ADDENDUM
NO. 03

February 19, 2026

Edwardsburg Public Schools – Middle School and High School Mechanical Upgrades

This Addendum consists of Pages ADD 3-6 through ADD 3-3, and TowerPinkster Addendum No. 03 Middle School Mechanical Upgrades, consisting on 60 pages, and TowerPinkster Addendum No. 03 High School Mechanical Upgrades, consisting of 48 pages.

1 / P 501 DOMESTIC WATER FILTRATION DETAIL
1/2" = 1'-0"

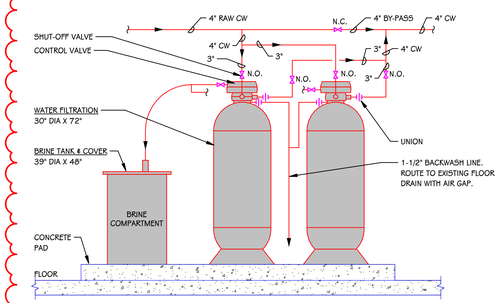
ADD-3 Item No. D-3 - Plumbing Water Filtration System

Added domestic water filtration system equipment to the mechanical room and keynote on P 101. Added schedule and detail on P 501.

FIRST FLOOR HVAC PIPING PLAN - UNIT D
1/8" = 1'-0"

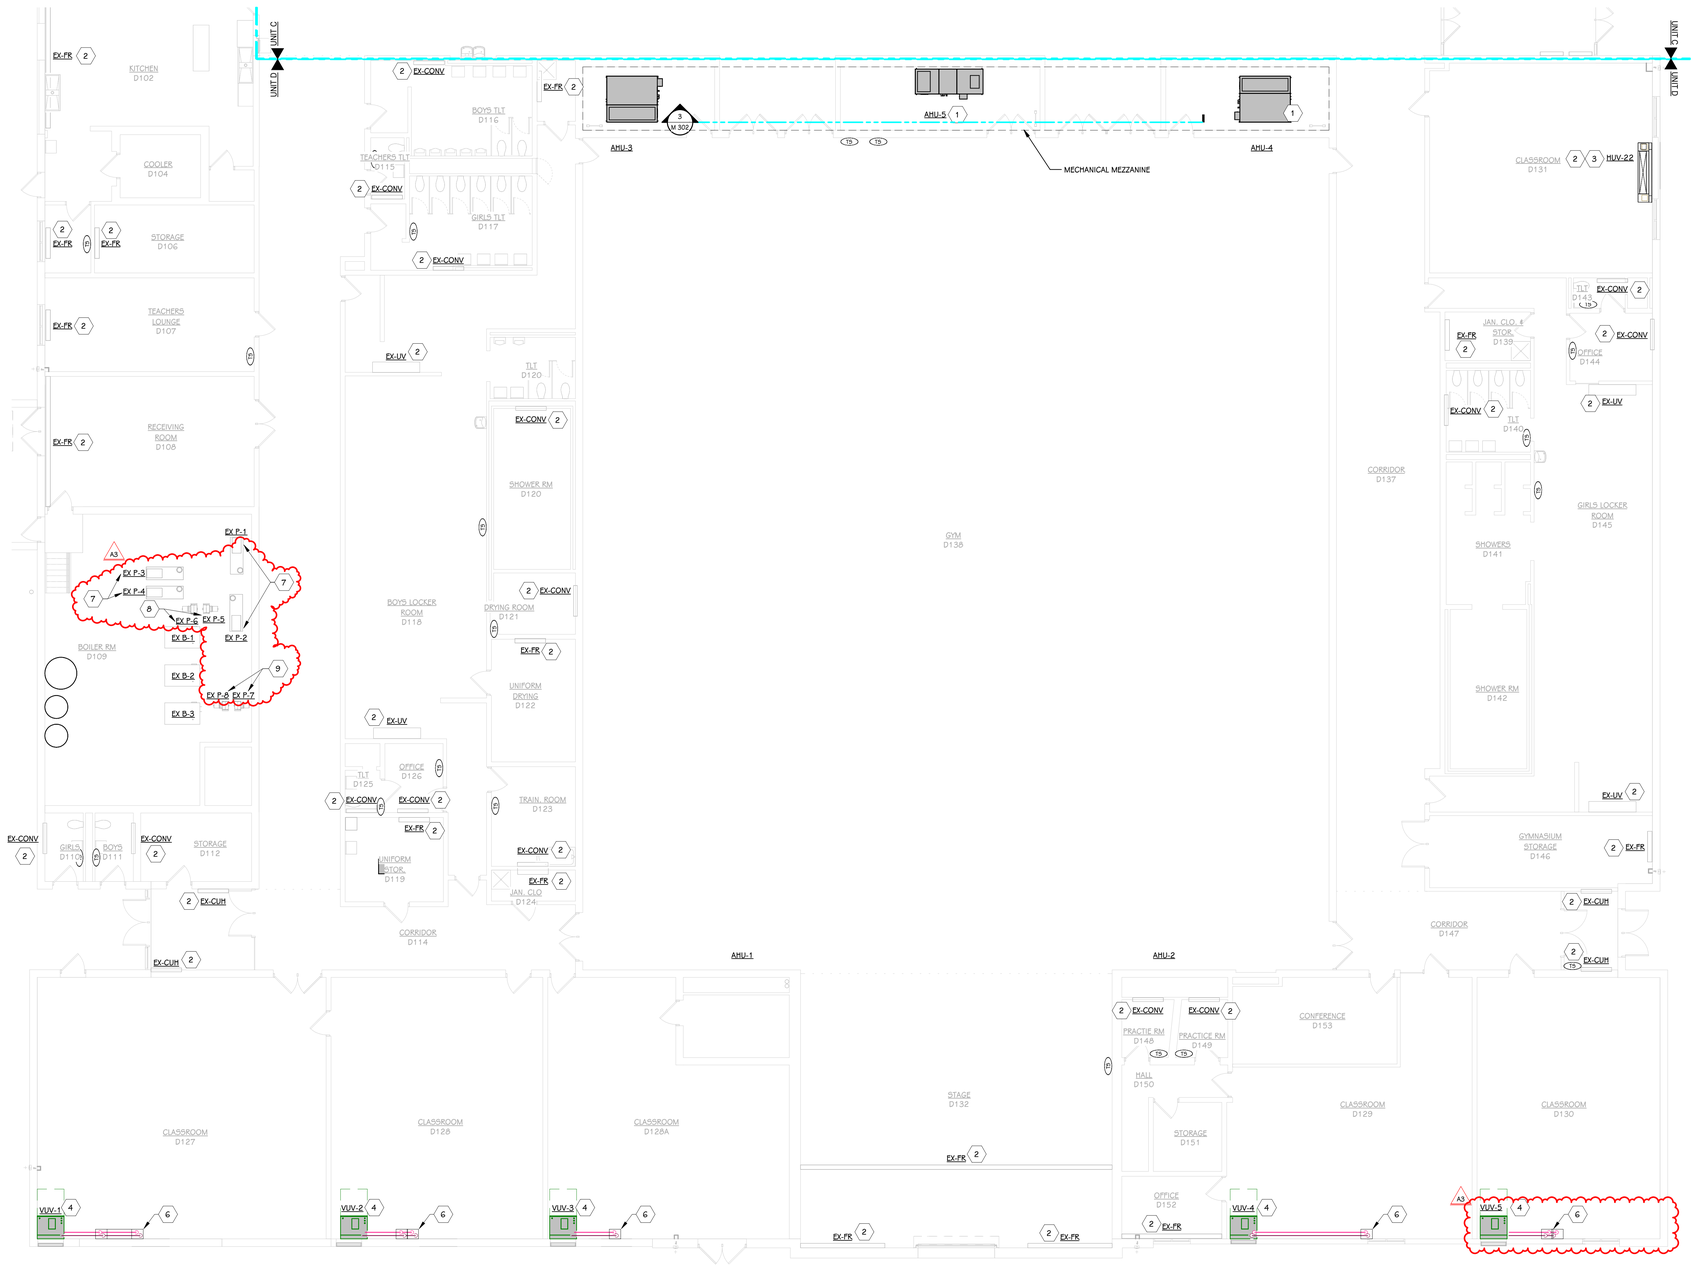
11	DA Dodd	2/11/2026	Can a schedule of new variable frequency drives be created and put into the Mechanical Schedule drawings for pricing, since mechanical package will be responsible to supply?	TP: In addendum 3, notes on Sheet M 201D revised showing existing pump information.
12	Herrman & Goetz	2/12/2026	Detail 1 on Sheet M504 shows the condensing unit to be installed on a slip sheet and composite pad. Section 3.2 of specification 23 6200 states to install roof mounted condensing untis on equipment curbs rails with isolators. Please clarify the intent for condensing unit installation. If condensing units need to be install on curbs rails, this will significantly increase the scope of roofing work.	TP: Instal per detail on M504. In addendum 3 spec section 23 6200 revised to include mounting requirements for condensing units 5 tons and smaller.

1 M 302 ENLARGED DEMOLITION PLAN - MEZZANINE D238
3/16" = 1'-0"

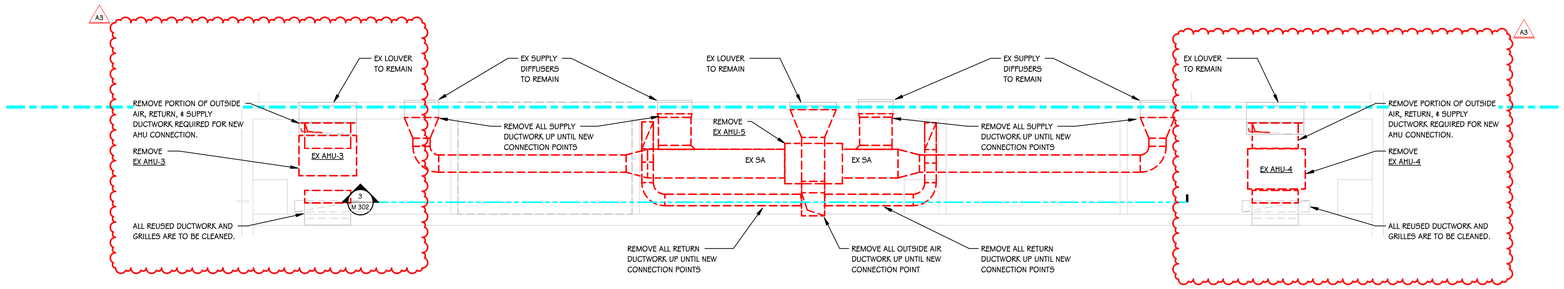
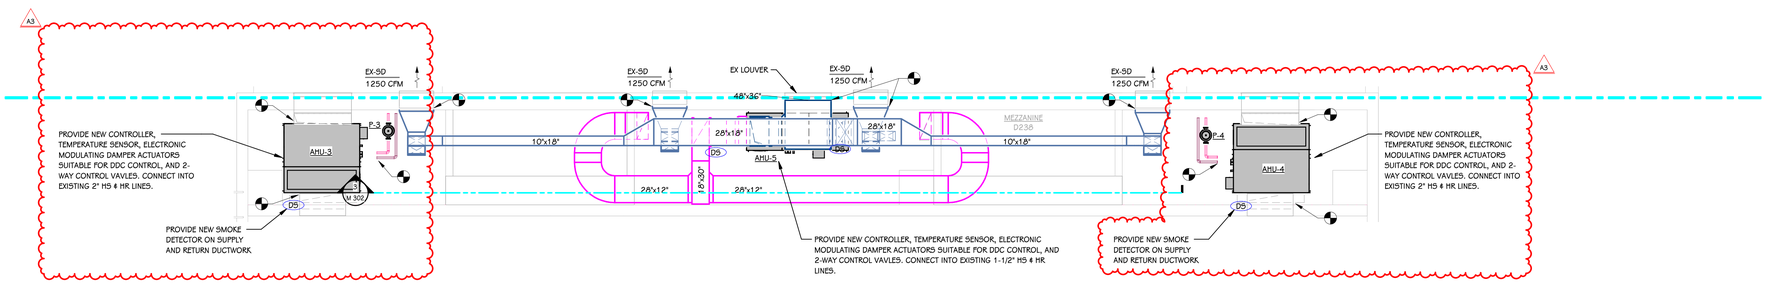
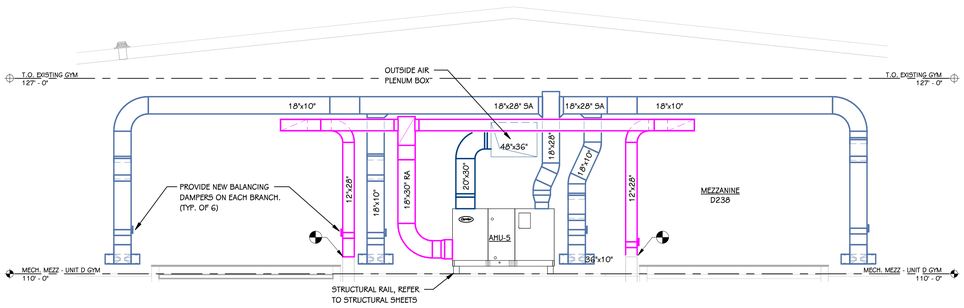
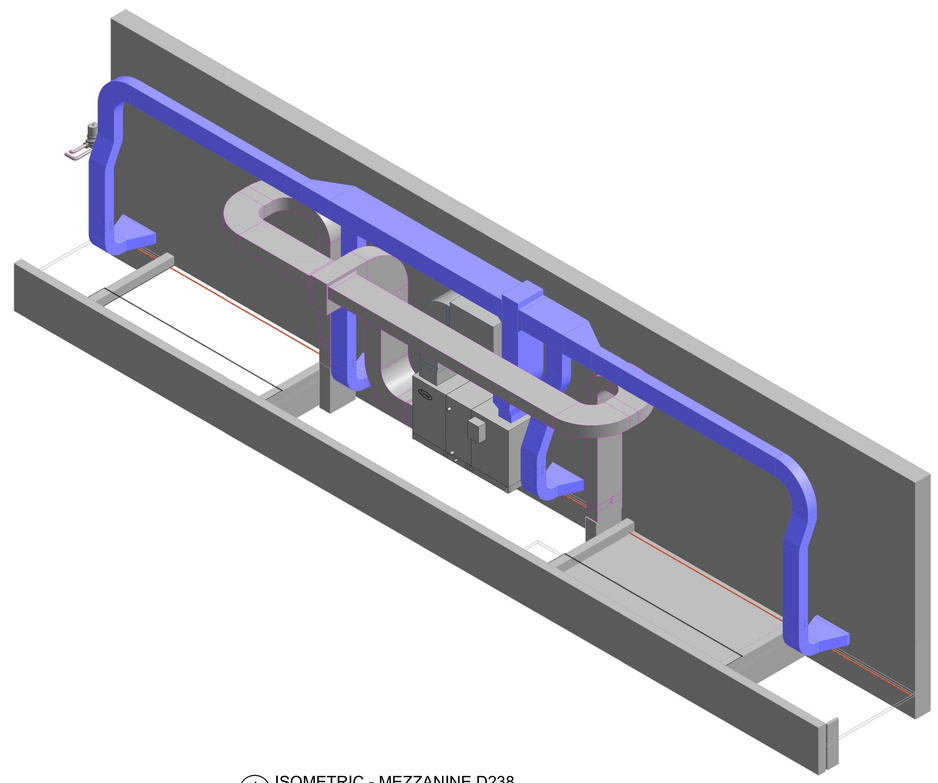
M 302 showing removal and installation of new AHU-3&4. Issued new sheet M 303 showing removal and installation of AHU-1 & 2. M 501 added AHU 1-4 schedule. M 502 added recirculation pumps serving AHU 1-4. Refer to G 001 for updated drawing index showing M 303.

FIRST FLOOR ELECTRICAL DEMOLITION PLAN - UNIT D

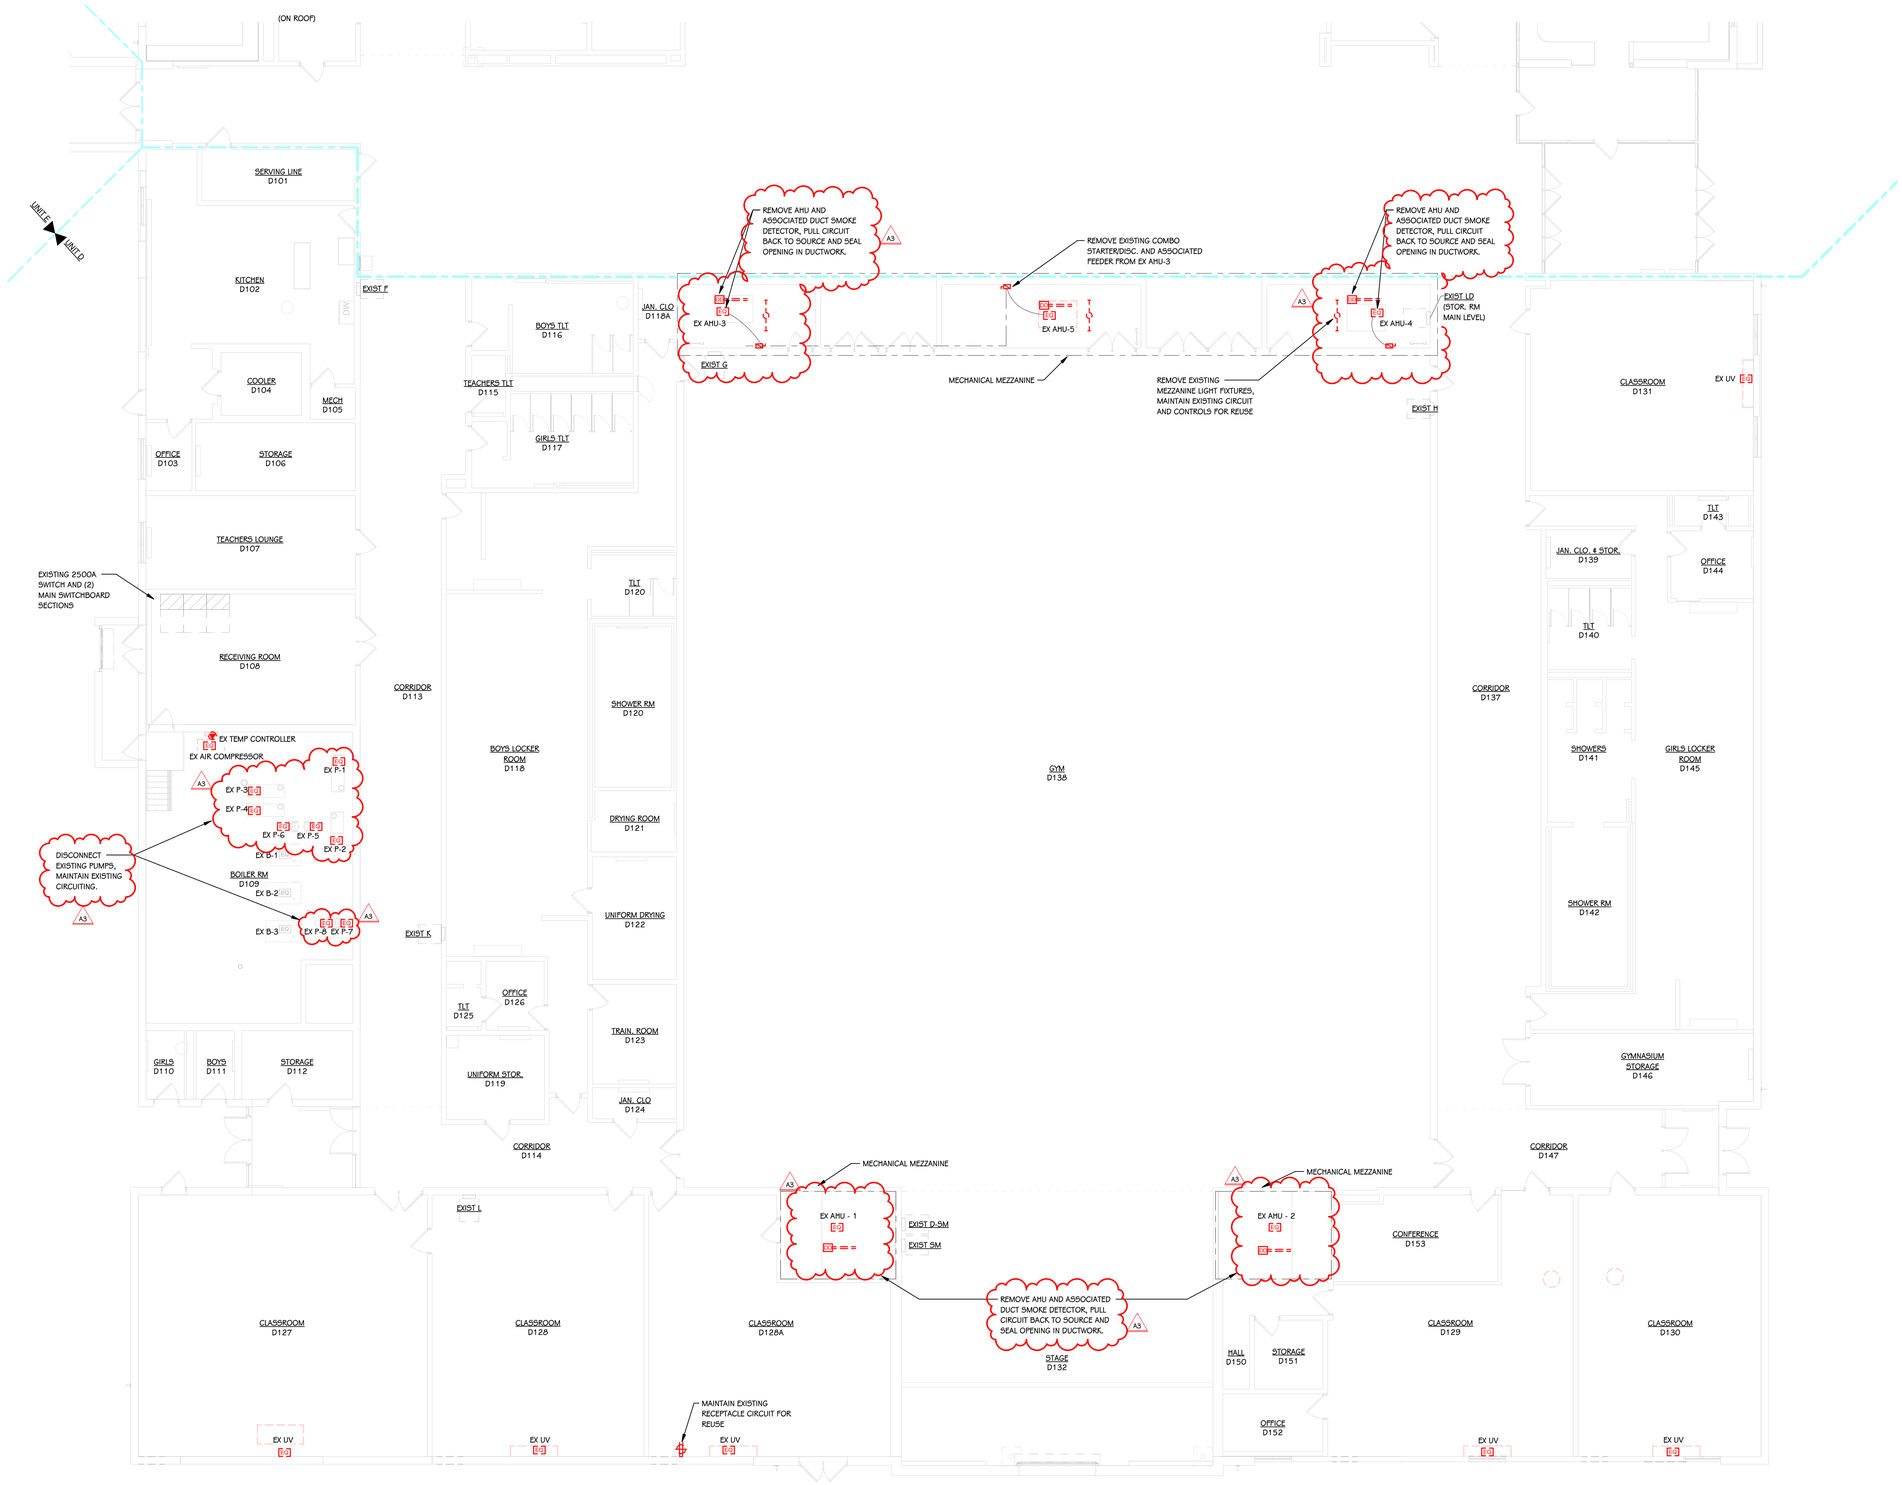
Showed demolition of pumps 1 through 8 in the boiler room and noted to maintain the existing circuit. Added new connections for identically sized pumps and noted to reconnect to existing circuit. Refer to drawings ED 101D and E 101D.

Showed demolition of AHU 1 through 4 in the mechanical mezzanines. Added new connections and circuiting for new AHUs and associated pumps. Updated the one-line diagram and electrical schedules to show new circuits. Refer to drawings ED 101D and E 101D for connection locations and drawings E 401 and E 402 for one-line and schedule changes.

FIRST FLOOR DEMOLITION LIGHTING PLAN - UNIT D

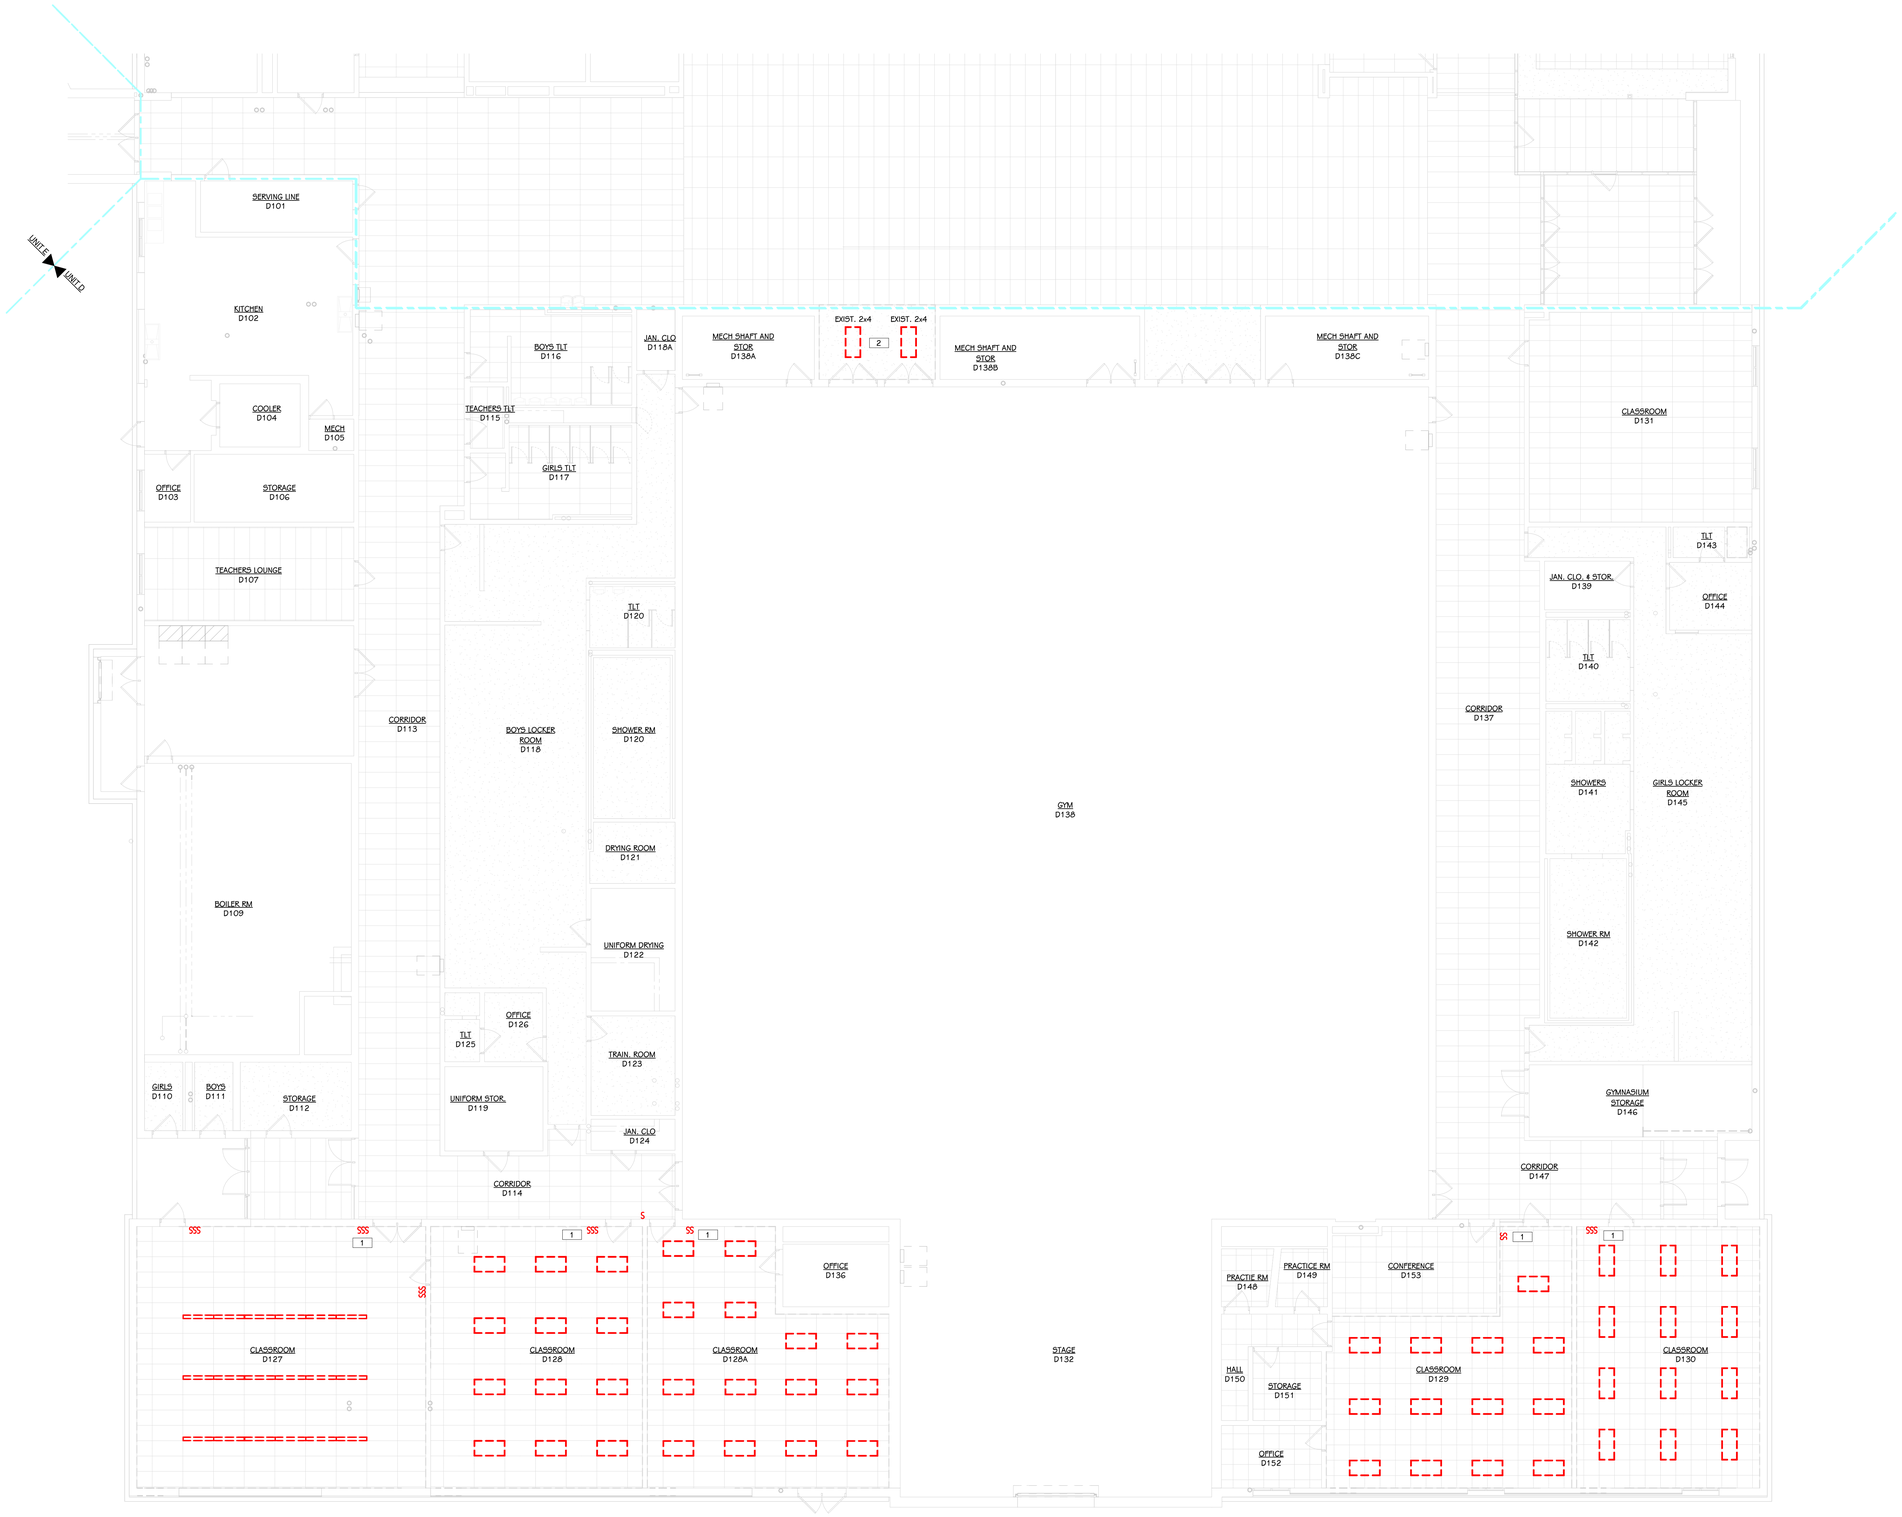
ADD-3 Item No. D-2 - Lighting Alternate Clarifications

Added a note describing the base bid work for lighting. Renamed the lighting drawings to clarify they are part of the alternate. Refer to drawings ED 201A, ED 201B, ED 201C, ED 201D for the base bid lighting work note. Refer to drawings E 201A, E 201B, E 201C, E 201D, E 420 for alternate Lighting work. Refer to G 001 for updated drawing index.
